# ENVIRONMENTAL IMPACT STATEMENT

## FINAL VOLUME 2

DEPARTMENT OF THE INTERIOR  
FINAL  
ENVIRONMENTAL IMPACT STATEMENT  
ON THE  
ENERGY TRANSPORTATION SYSTEMS INC.  
COAL SLURRY PIPELINE  
TRANSPORTATION PROJECT

BUREAU OF LAND MANAGEMENT (LEAD AGENCY)  
AND WOODWARD-CLYDE CONSULTANTS

Figure H-3. COMPARISON OF COMPUTED AND OBSERVED DRAWDOWNS FOR THE GILLETTE WELL-FIELD PUMPING TEST

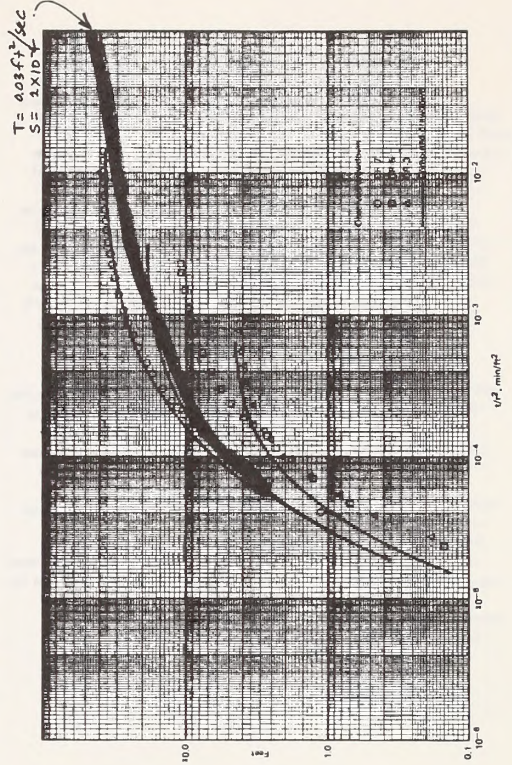
Comment: Although the conceptual model is probably the best and most reasonable proposed to date, the fact remains that use of the "effective average of the properties" cannot reproduce field results on a local scale.

The attached example, plotted on Figure H-3, shows this and, further, that use of the parameters specified for the model would predict increasingly larger drawdowns as time progresses.

Figure 5-7. DRAWDOWNS (in feet) IN THE MADISON AQUIFER POTENTIOMETRIC SURFACE AFTER 50 YEARS (1985-2035) OF PUMPING FROM CROOK COUNTY WELL FIELD ONLY (PLAN 3)

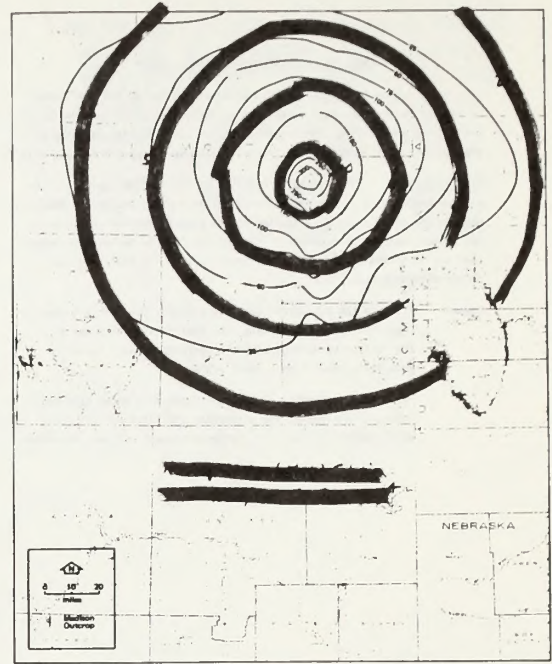
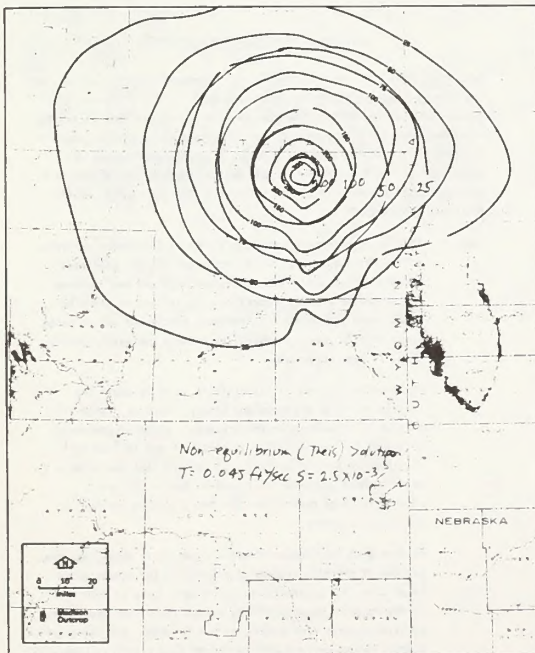
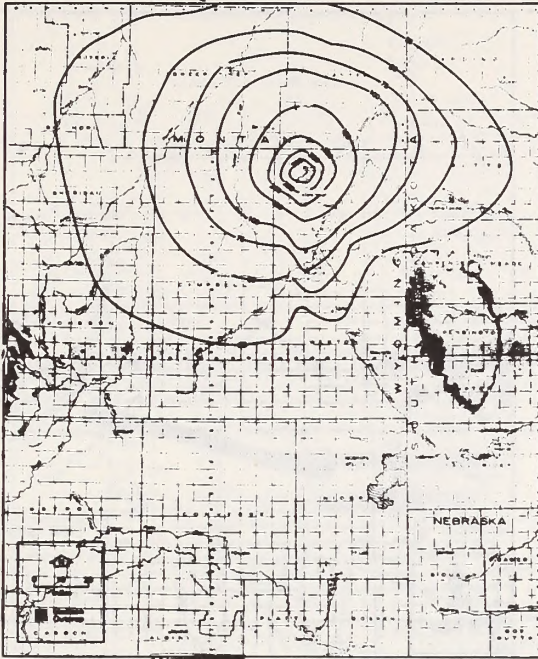
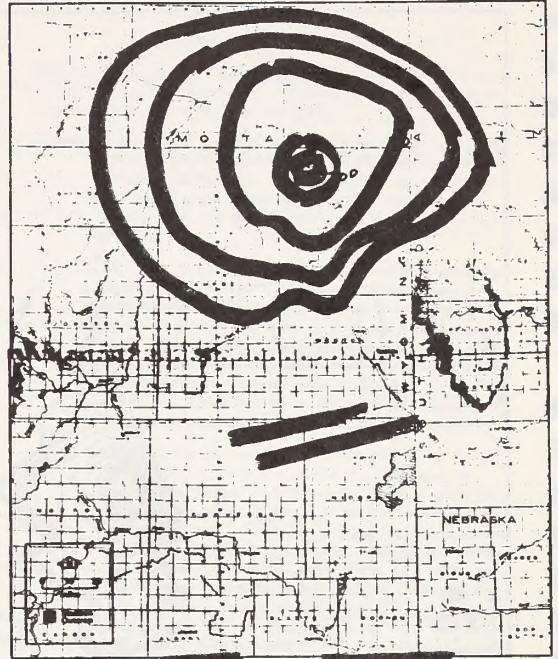
The importance of the specific storage can be shown on the attached modifications of Figure 5-7 of the Technical Report. The following explanation will be as brief as possible because the authors are familiar with the criteria used.

Comparison of the two examples shows that the change in specific storage greatly affects the magnitude and extent of predicted drawdowns. It would appear reasonable to assume comparable changes would result if the higher specific storage value were used in the model simulation. In fact, it appears that the data points used in South Dakota (Figure 5-2 and Table 5-1) might show predicted drawdowns of less than 25 feet in another model simulation.

If that were the case, the impacts there would not be considered significant. Page 4-1 para 3 of the DEIS states, "Impact on the hydrology of the Madison aquifer system would be considered potentially significant if drawdowns in the potentiometric surface exceeded 25 feet----".

Figure 5-31. DRAWDOWNS (in feet) IN THE MADISON AQUIFER POTENTIOMETRIC SURFACE AFTER 50 YEARS (1985-2035) OF PUMPING FROM NIOBRARA COUNTY WELL FIELD ONLY (PLAN 1)

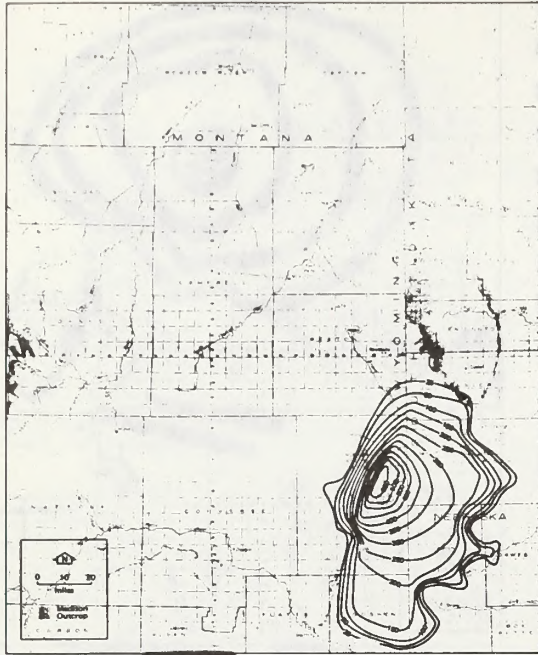
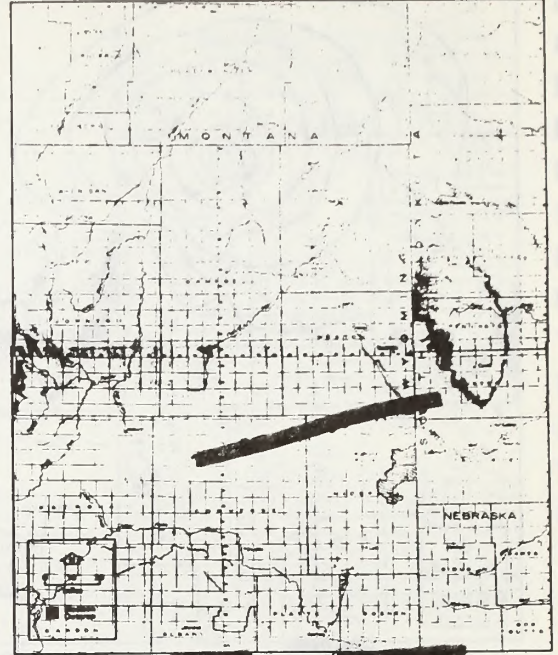
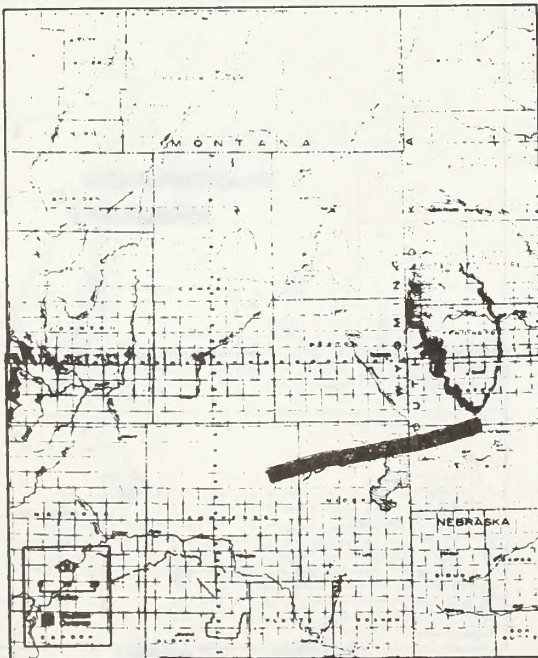
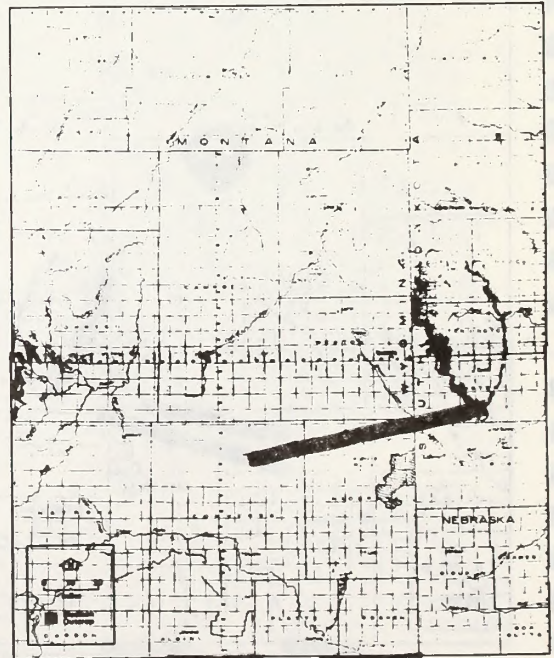
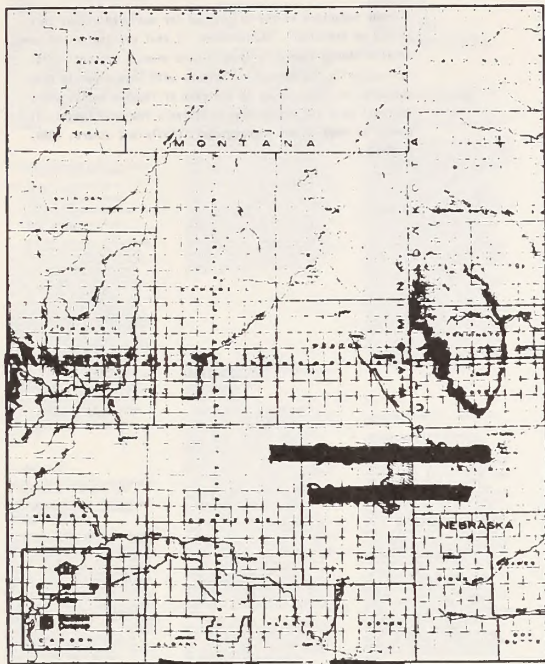
Page 5-1, Chapter 5. Impacts Caused by Pumping from the Madison Aquifer System. Figures 5-3, 5-5, 5-7, 5-9, 5-11, 5-12, 5-14, 5-16 and 5-18 depict calculated drawdowns in the Madison aquifer system by use of contours of equal drawdown.

Comments: These maps confuse the average reader and convey the idea that the drawdowns shown will occur in all aquifer systems, even in those wells that penetrate only the uppermost aquifer such as in the Inyan Kara Group. ("Dakota", that includes the Lakota and Fall River formations) It is suggested that, for each of the scenarios portrayed, figures above be expanded to show the calculated drawdowns in the aquifer units shown on Figure 4-3 that occur above the Madison. These would include the Upper Minnelusa, the uppermost part of the Upper Confining Unit (Fall River Formation), and alluvial deposits of stream valleys. It may be necessary to include the Arikaree for the Niobrara County field because of its occurrence there. Examples of Plan 3 (Crook County Well Field) supplemented figures are attached. The contours on these examples were not calculated and the values shown were selected on the basis of judgment for illustrative purposes.

FIGURE VII-4  
ASSESSED VALUATION  
PER UNIT OF POPULATION  
OVER TIME

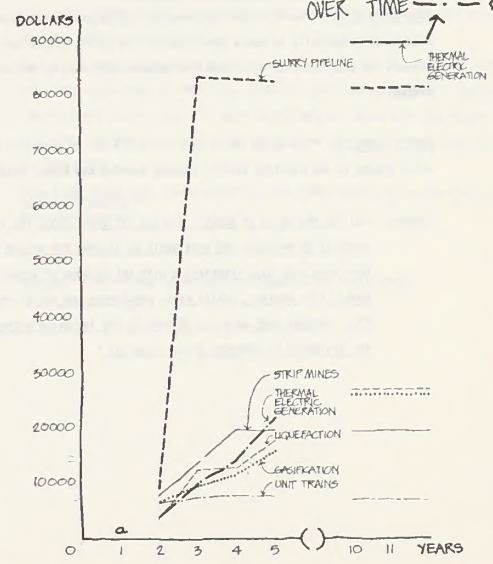
Comment: This is an erroneous statement. Change it to reflect the fact that ETSI will generate about \$3.4 million of additional tax revenue per year for a pipeline 104 miles long, a tax fallout of around \$35,000 per mile from the main slurry pipeline. In contrast, railroads, according to data provided by the UP representative to the Farm Bureau Transportation Committee, will produce about \$1,500 per mile.

Add that "According to 'Coal Development Alternatives' prepared by OEPAO for the Wyoming State Legislature in December, 1974, other types of projects such as gasification, liquefaction and unit trains produce on the order of \$10,000 to \$25,000 assessed valuation per unit of population over time. By comparison, coal slurry pipelines and electrical generating plants will produce over \$80,000 per unit of population. So pipelines contribute relatively more to the tax base than most other types of projects." Include attached chart showing this.
